CALIFORNIA COASTAL COMMISSION

May 22, 1998

SUBJECT: Proposed Major Amendment (2-97) to the University of California Santa Barbara Certified Long Range Development Plan for Public Hearing and Commission Action at the June 9, 1998, Commission Meeting in Santa Barbara.

STAFF NOTE

EXHIBIT 3a
UCSB LRDPA 2-97
Site Plan-Lagoon Barrier

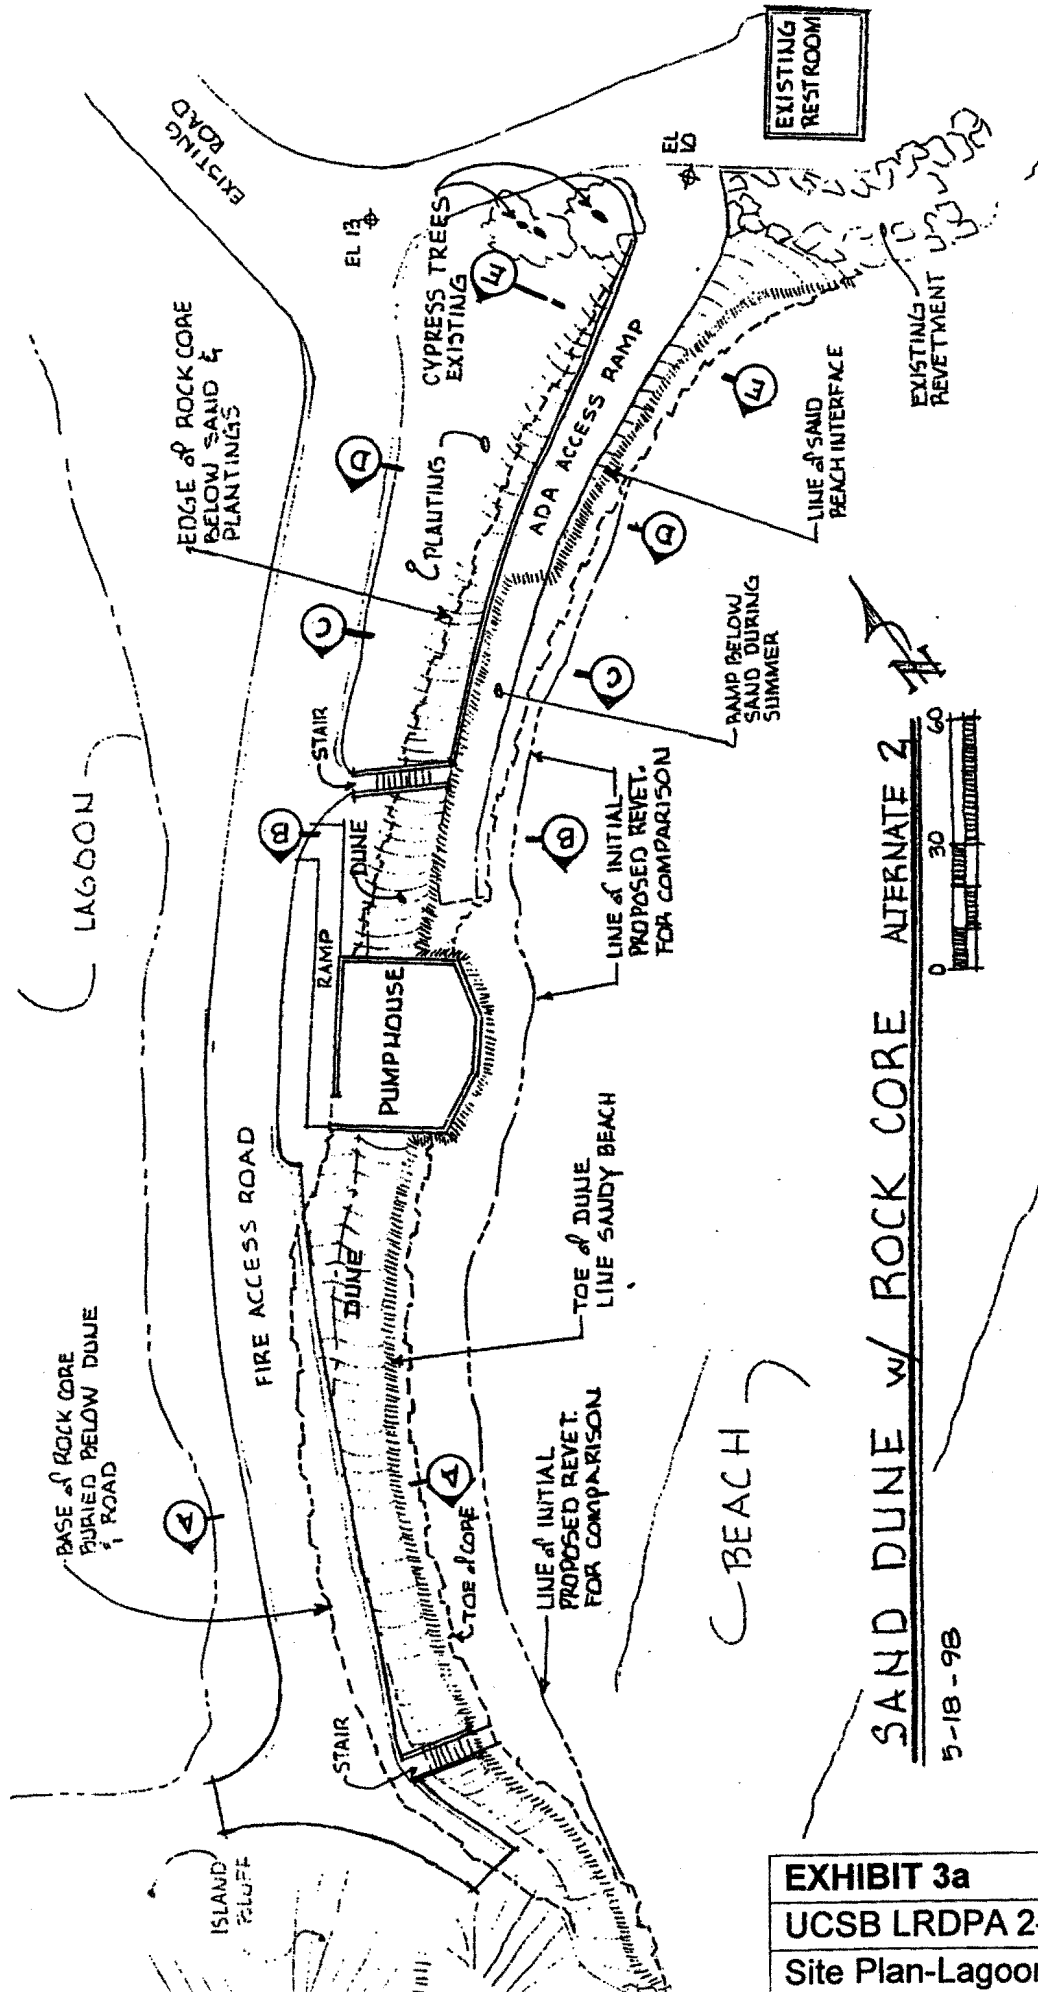
The University has now modified the originally proposed project to substitute the construction of a 460 ft. long, 10 ft. high, 15-32 ft. wide, rock revetment core/dune (Exhibit 3a) for the originally proposed 460 ft. long, 10 ft. high, 15-37 ft. wide, rock revetment core/dune (Exhibit 7), add a second stairway to the south of the pumphouse, and remove approximately 400-450 linear feet of existing revetment located south of the project site at Goleta Point. The primary differences between the new and the original proposal is that the rock revetment core/dune would be located further landward and constructed with a steeper face slope of 1.5:1 (H:V) than the originally proposed rock revetment which would have been constructed at a 2:1 (H:V) slope. In addition, the University would implement an annual program of sand placement on top of the rock structure. The more steeply angled revetment design of the rock revetment core/dune would serve to reduce the footprint of the structure and would be located further landward than the previous proposal in order to decrease impacts to the sandy beach.

However, since the University has submitted only preliminary sketches for the proposed modification, it is not possible to accurately determine how much further landward the proposed rock revetment core/dune would be located than the originally proposed project. Staff recognizes that although the rock revetment core/dune alternative submitted by the University does appear to occupy a smaller portion of certain segments of the beach south of the pump house, the preliminary sketches submitted by the University also appear to indicate that the proposed rock revetment core/dune would occupy substantially the same amount of beach as the original proposal for all portions of the beach located to the north of the pump house. Further, staff notes that the proposed rock revetment core/dune could feasibly be located significantly further landward to the north of the pump house through relocation of the proposed ramp and relocation of the rock core revetment/dune further landward both north and south of the pump house.

Although aspects of the new shoreline protection device component of the project now proposed by the University are an improvement over the previous proposal, staff notes that with additional modifications to the shoreline protective device aspect of the project proposal, the adverse impacts to public access and sand supply from direct occupation of the sandy beach by the structure could still be further significantly minimized. Commission staff is willing to continue to work with the University towards developing an acceptable alternative form of shoreline protection which may include relocation of the proposed ramp and revetment further landward in order to minimize occupation of the sandy beach by rock. Further, Staff will consider any direction provided by the Commission regarding the development of an acceptable alternative form of shoreline protection.
